ADDENDUM NO. 2

June 5, 2023

LAKE STREET ELEMENTARY SCHOOL ADDITIONS, RENOVATIONS, AND RELATED WORK

Addendum Two (AD.02) to the drawings and specifications prepared by Gibraltar Design for **Lake Street Elementary School Improvements** for Crown Point Community School Corporation, Crown Point, Indiana.

© GIBRALTAR DESIGN SHEET
MV104

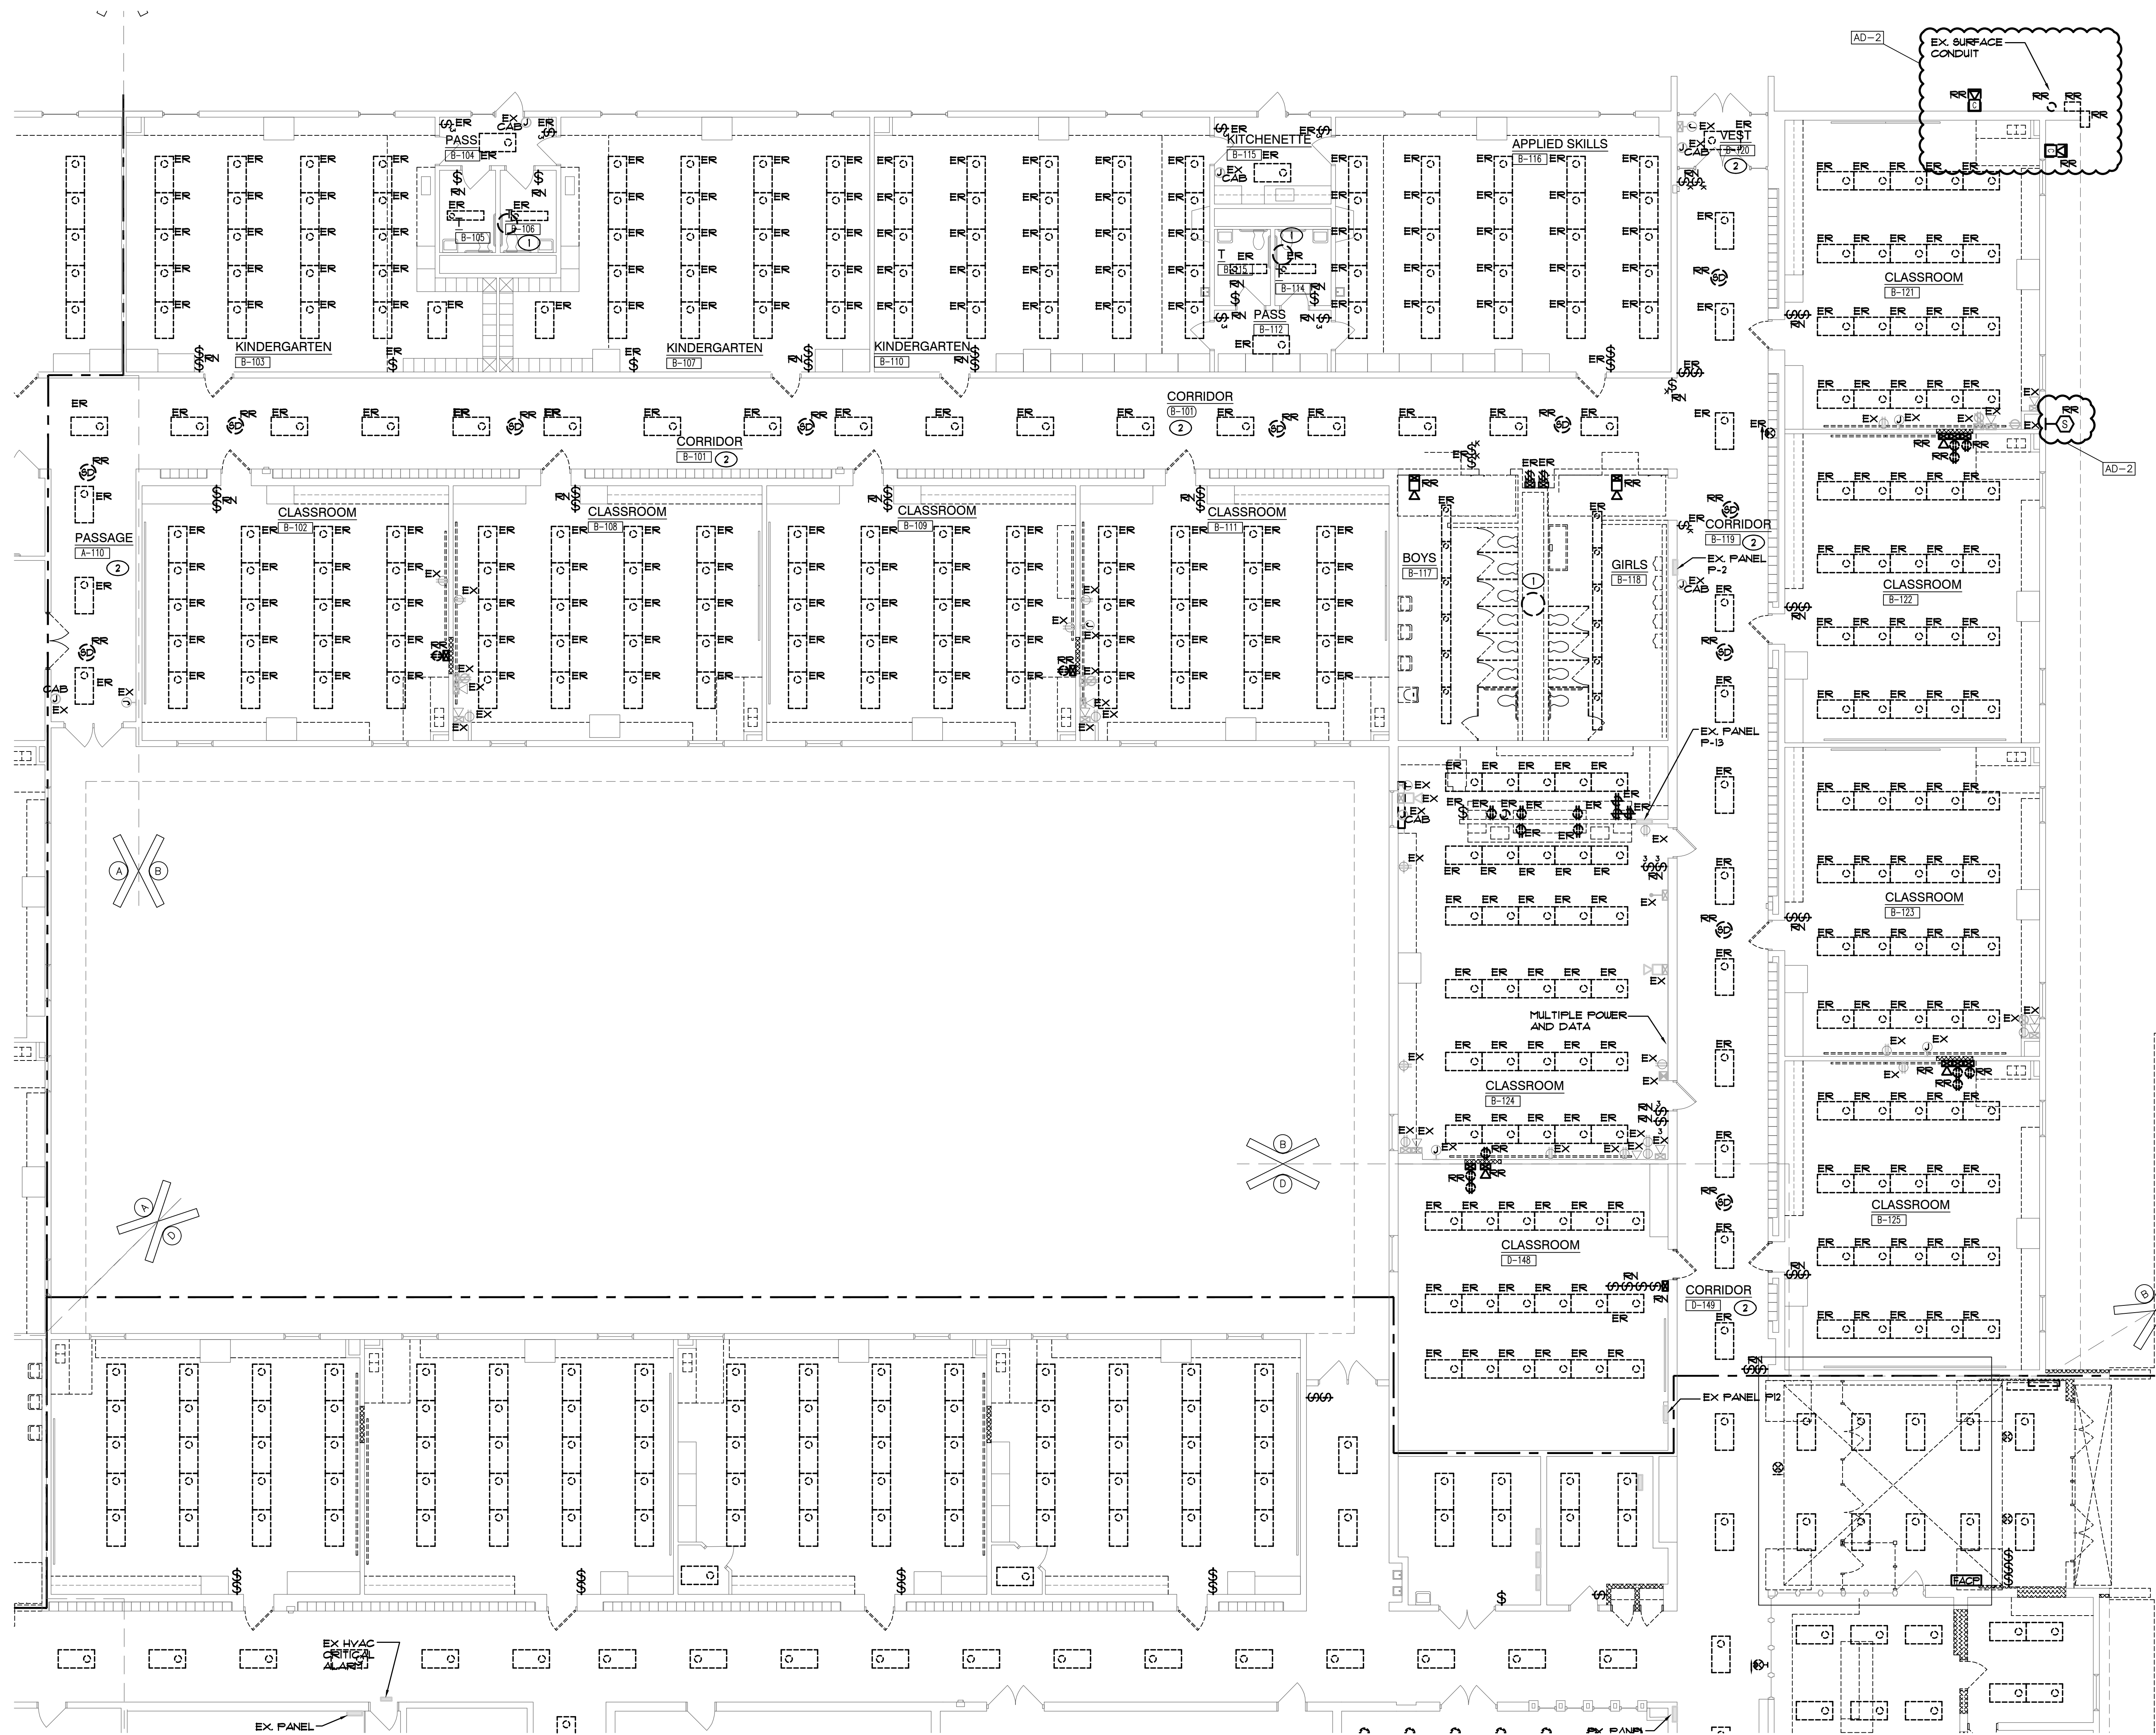
10. Sheet MV-104

- A. Refer to revised, full-size drawing, included in this Addendum, for the following revisions:
 - 1. Added Supply Air Grille and Ductwork to Storage D-102

DRAWING
PARTIAL ELECTRICAL
FIRST FLOOR LIGHTING
PLAN

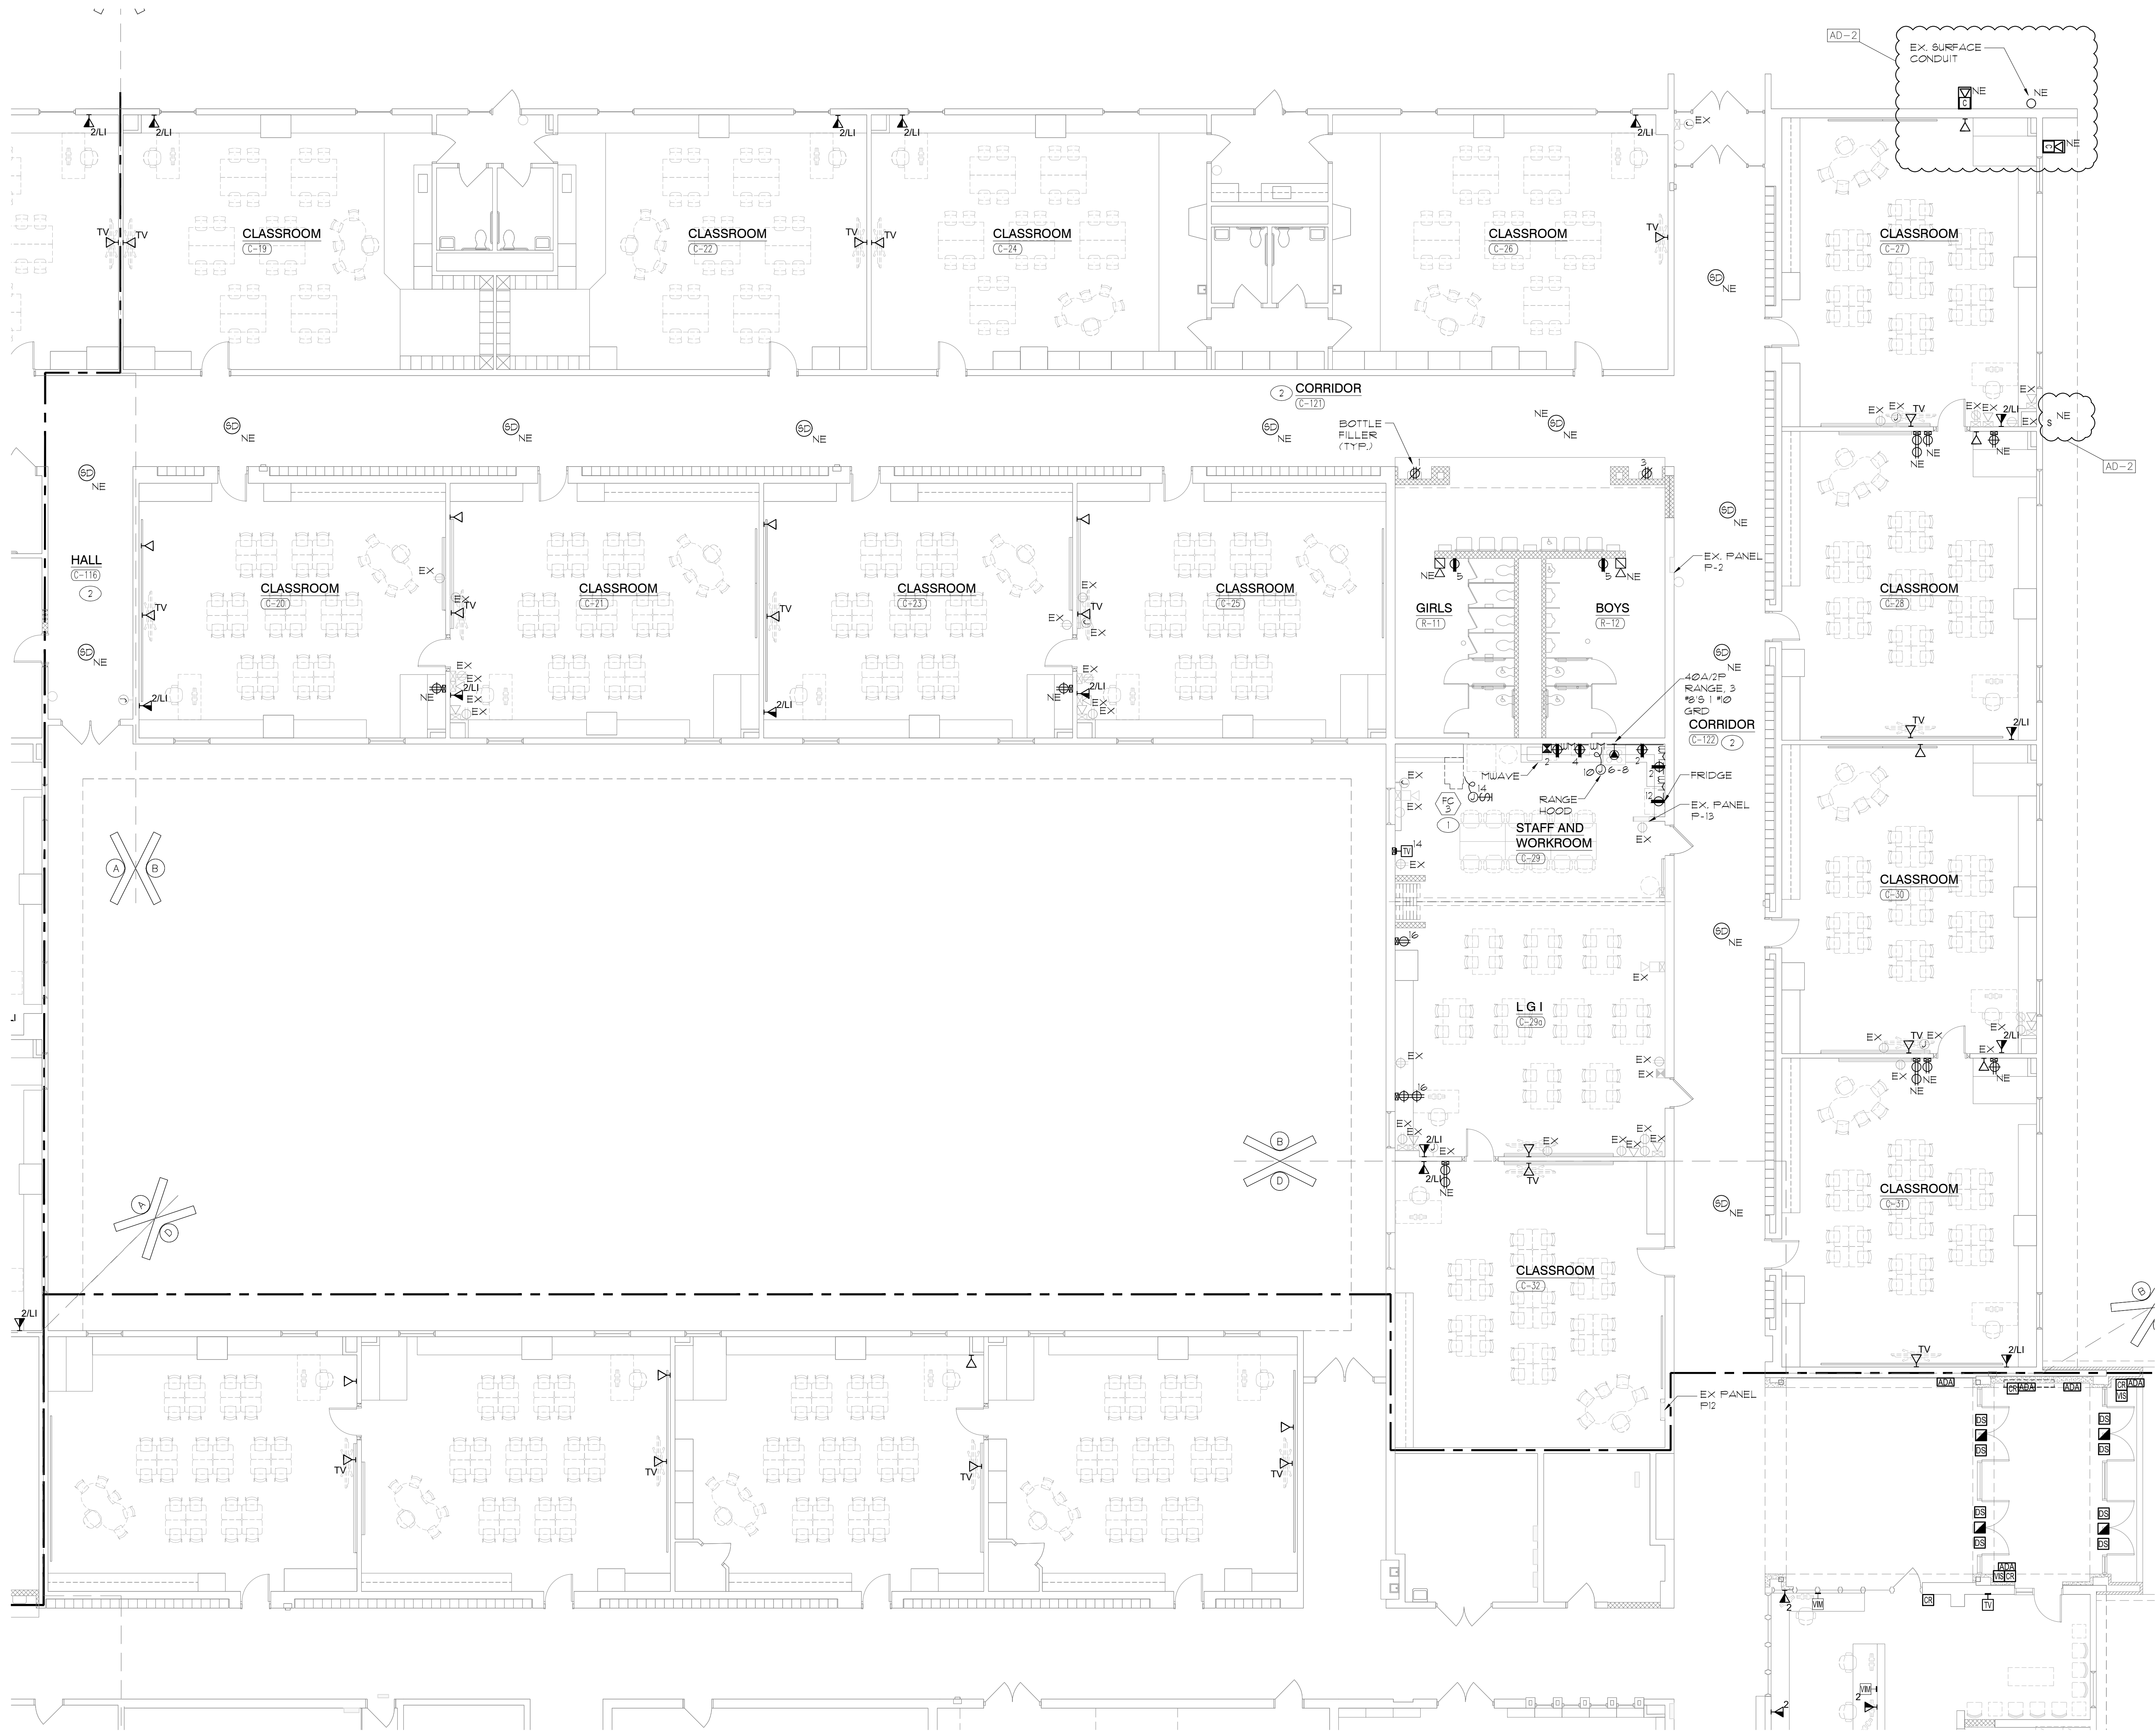
13. Sheet ED-102

- A. Refer to revised, full-size drawing, included in this Addendum, for the following revisions:
 - 1. Added existing devices to be relocated

© GIBALTAR DESIGN SHEET
EP102

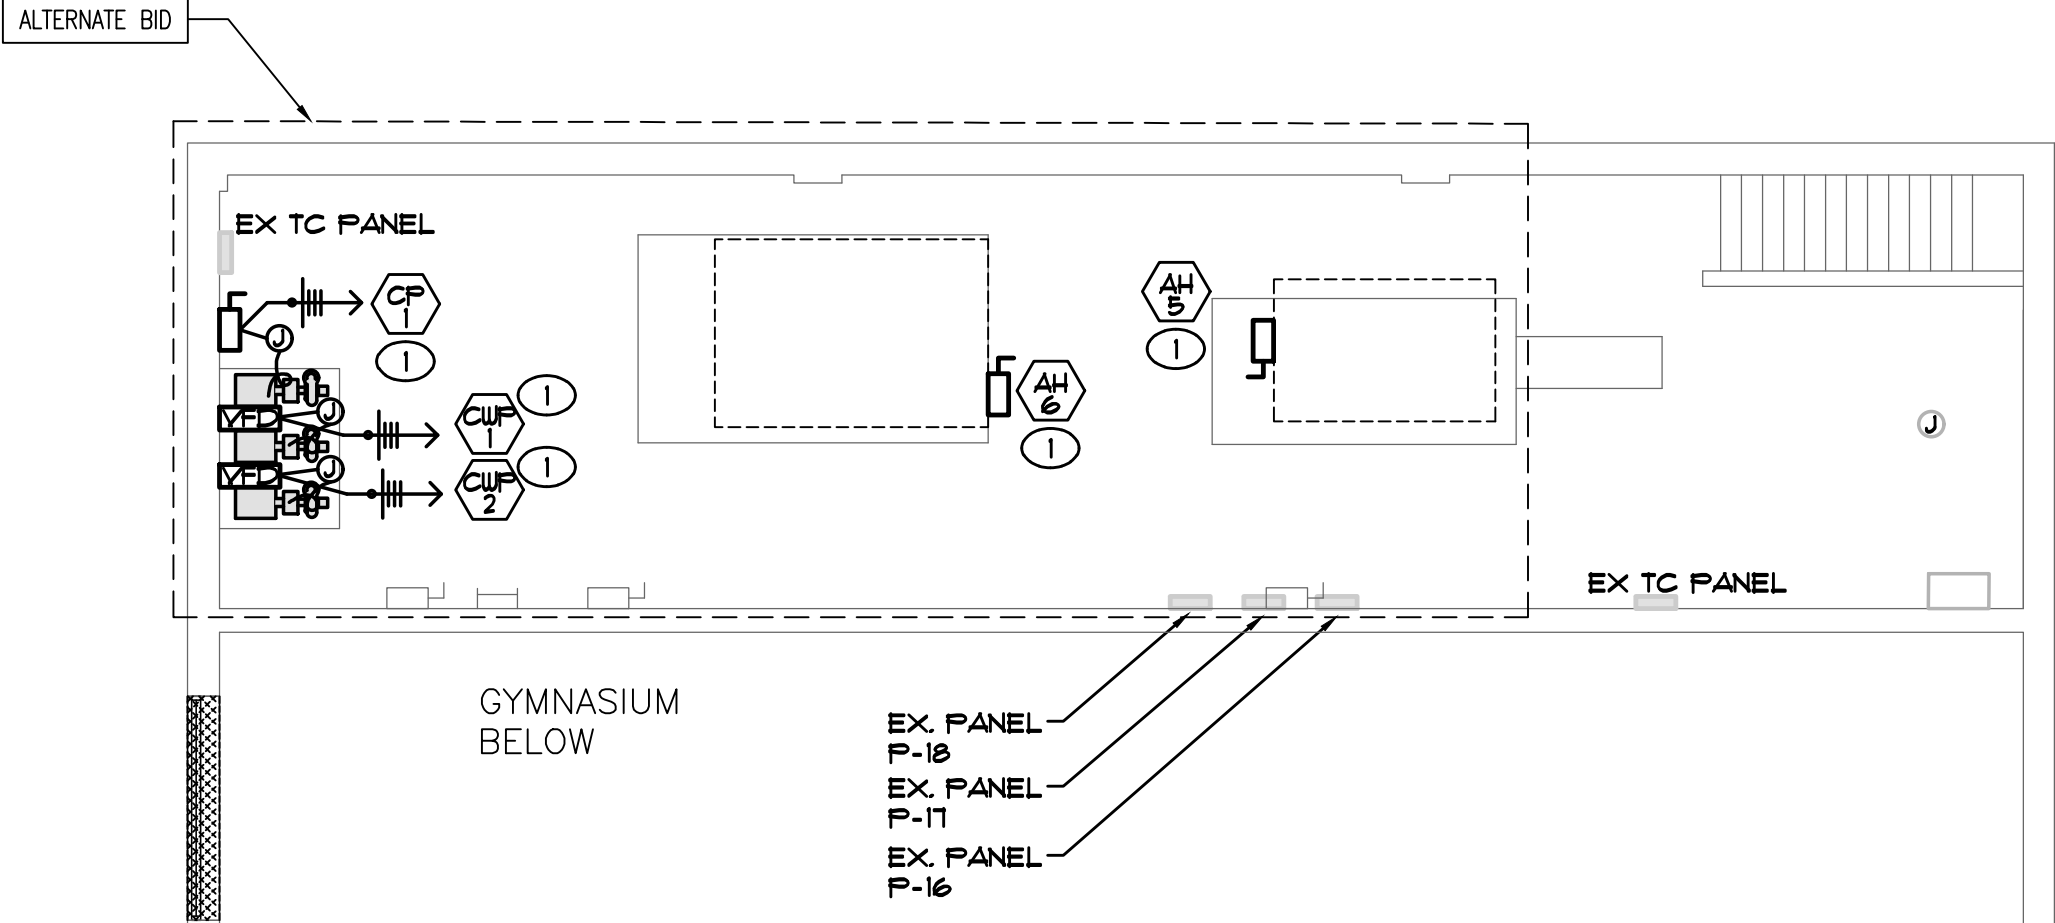
19. Sheet EP-102

- A. Refer to revised, full-size drawing, included in this Addendum, for the following revisions:
 1. Added relocated devices
